UNITED STATES  
NUCLEAR REGULATORY COMMISSION  
WASHINGTON, D.C. 20555-0001

SUBJECT: LIMERICK GENERATING STATION, UNITS 1 AND 2 - STAFF ASSESSMENT OF INFORMATION PROVIDED PURSUANT TO TITLE 10 OF THE *CODE OF FEDERAL REGULATIONS* PART 50, SECTION 50.54(f), SEISMIC HAZARD REEVALUATIONS FOR RECOMMENDATION 2.1 OF THE NEAR-TERM TASK FORCE REVIEW OF INSIGHTS FROM THE FUKUSHIMA DAI-ICHI ACCIDENT (TAC NOS. MF3864 AND MF3865)

STAFF ASSESSMENT BY THE OFFICE OF NUCLEAR REACTOR REGULATION  
RELATED TO SEISMIC HAZARD AND SCREENING REPORT  
LIMERICK GENERATING STATION, UNITS 1 AND 2  
DOCKET NOS. 50-352 AND 50-353

Figure 3.3-1 Plot of NRC's and Licensee's Base Case Shear-Wave Velocity Profiles for the LGS Site

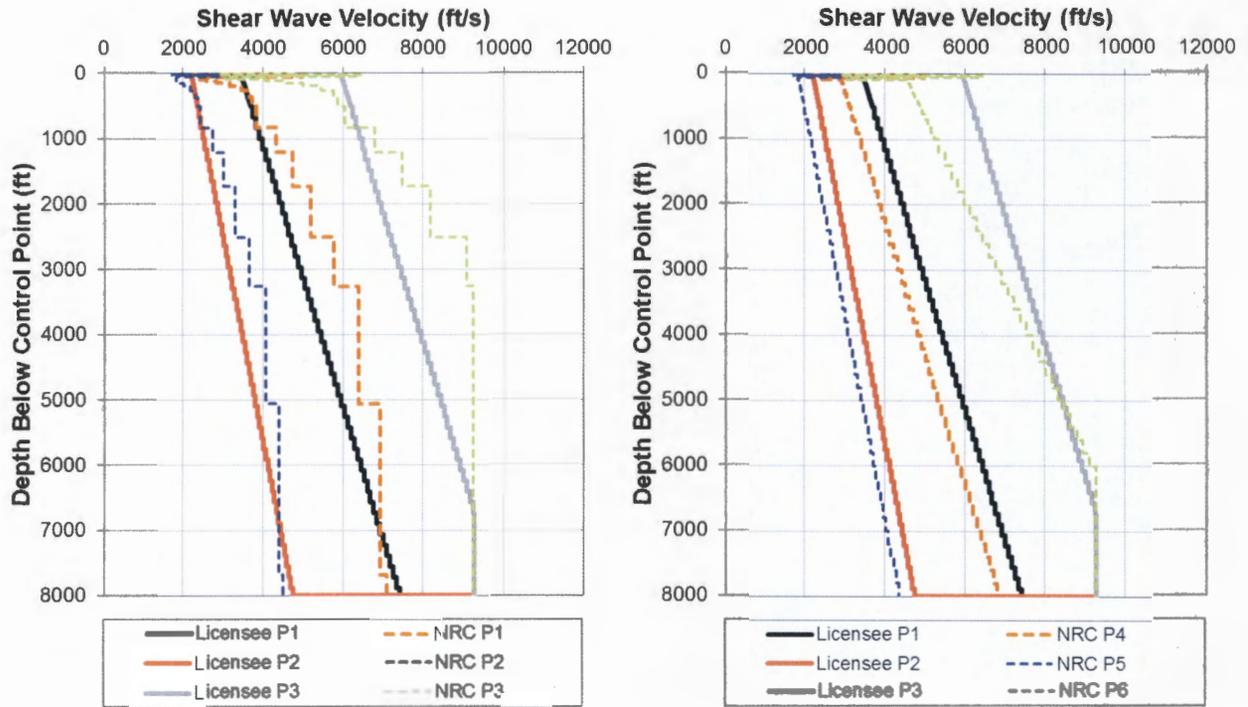
The NRC staff used the ISFSI shear wave velocity data to characterize the dynamic properties in the upper 50 ft. (15 m). The NRC staff used the SPID template velocity profiles and a constant velocity gradient (as shown in Figure 3.3-1 of this assessment), to estimate the shear wave velocity at depths greater than 50 ft. (15 m). The NRC staff used a scale factor of 1.28, corresponding to a natural log standard deviation of 0.25, to estimate lower and upper base case velocity profiles. The NRC staff velocity profiles differ moderately from those proposed by the licensee.

Figure 3.3- 1 Plot Comparing the NRC's and the Licensee's Median Amplification Functions and Uncertainties for the LGS site.

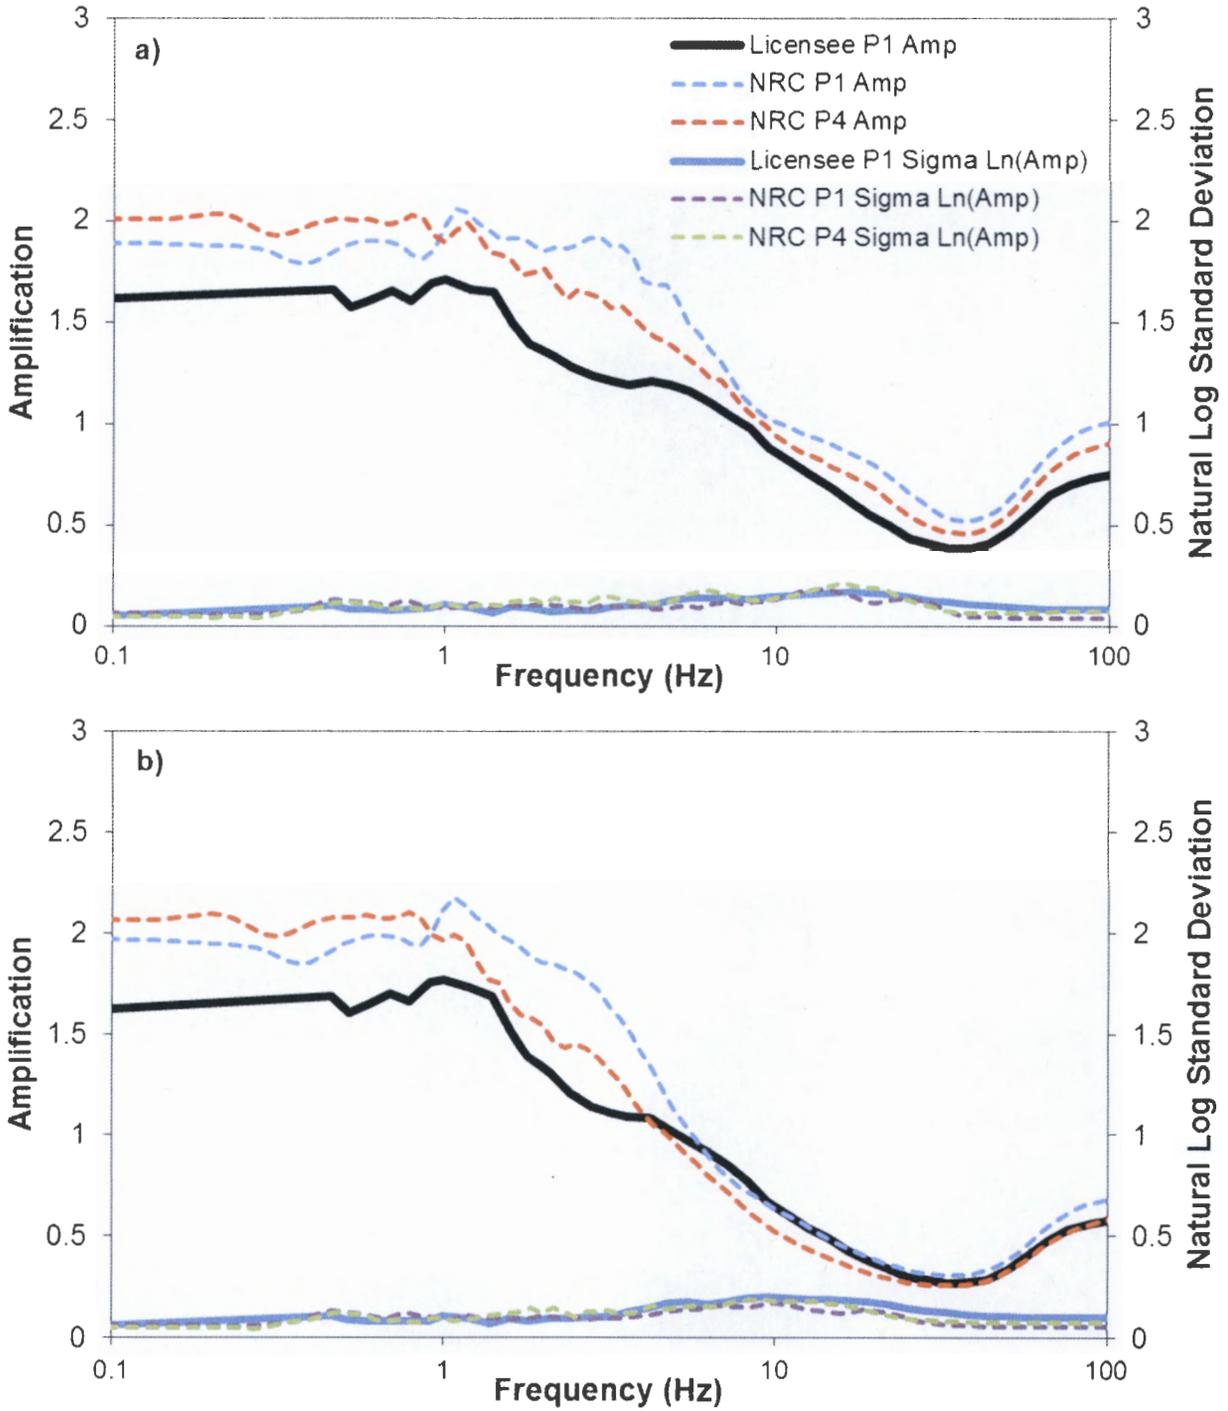
Figure 3.3-2 of this assessment shows a comparison of the NRC staff's and licensee's median site amplification functions and uncertainties for 2 of the 11 input loading levels. At low acceleration amplitudes, the amplification functions are slightly greater than the licensee amplification functions (Figure 3.3-2a). The difference between NRC and licensee amplification functions above 1 Hz reduces with larger input acceleration amplitudes. The amplification function standard deviation computed by the NRC staff and licensee are similar.

The difference between the licensee and NRC staff shear wave velocity profiles is the most significant factor leading to differences the amplification functions. The differences in amplification function lead to minor differences in the hazard curves shown in Figure 3.3-3 of this assessment. The shape of the control point hazard curves are similar. At 1 Hz, the licensee hazard curve is slightly steeper. Appendix B of the SPID provides guidance for performing site response analyses, including capturing the uncertainty for sites with less subsurface data; however, the guidance is neither entirely prescriptive nor comprehensive. As such, alternative approaches in performing site response analyses, including the modeling of uncertainty, are acceptable for this application.

Figure 3.4-1 Comparison of the NRC's GMRS with Licensee's GMRS and the SSE for the LGS site

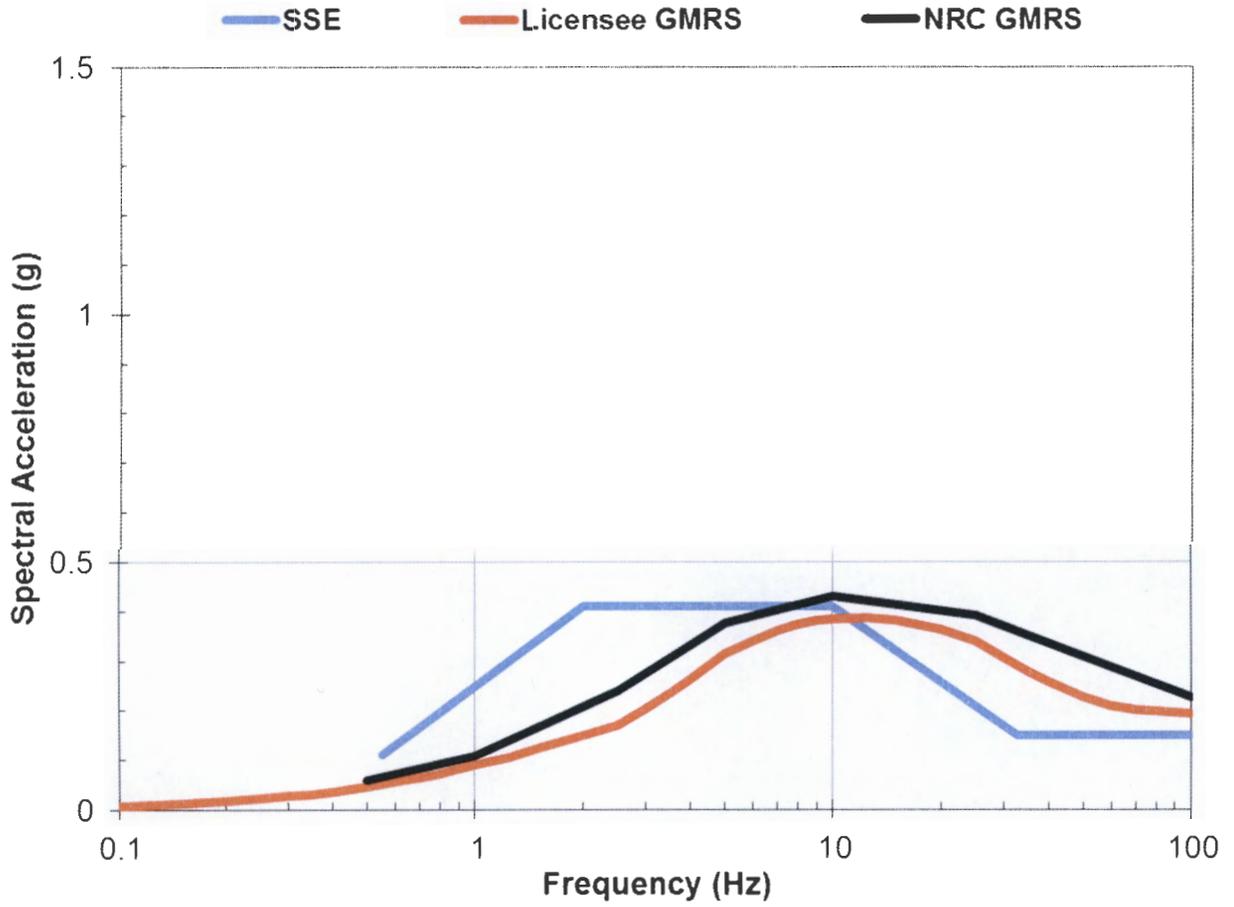
The NRC staff independently calculated the  $10^{-4}$  and  $10^{-5}$  UHRS using the results of its confirmatory PSHA and site response analysis, as described in Sections 3.2 and 3.3 of this staff assessment, respectively. Figure 3.4-1 of this assessment shows a comparison of the GMRS determined by the licensee to that determined by the NRC staff.

As shown in Figure 3.4-1 below, the licensee's GMRS shape is generally similar to that calculated by the NRC staff. At frequencies where the amplitude of the GMRS determined by the licensee is different from that determined by the NRC staff, the staff's GMRS generally exceeds that of the licensee. These differences in GMRS are the result of differences in the site response analyses performed by the licensee and NRC staff as discussed in Section 3.3 above.

In reaching this determination, the NRC staff confirmed the licensee's conclusion that the licensee's GMRS for the LGS is bounded by the SSE for the LGS site in the frequency range of 1 to 10 Hz and exceeds the SSE in the frequency range above approximately 10 Hz. As such, a seismic risk evaluation (Item 8) and SFP evaluation (Item 9) are not merited. However, a HF confirmation (i.e., Item (4)) is merited for the LGS site. The NRC review and acceptance of Exelon's HF confirmation for LGS will complete Seismic Hazard Evaluation identified in Enclosure 1 of the 50.54(f) letter.
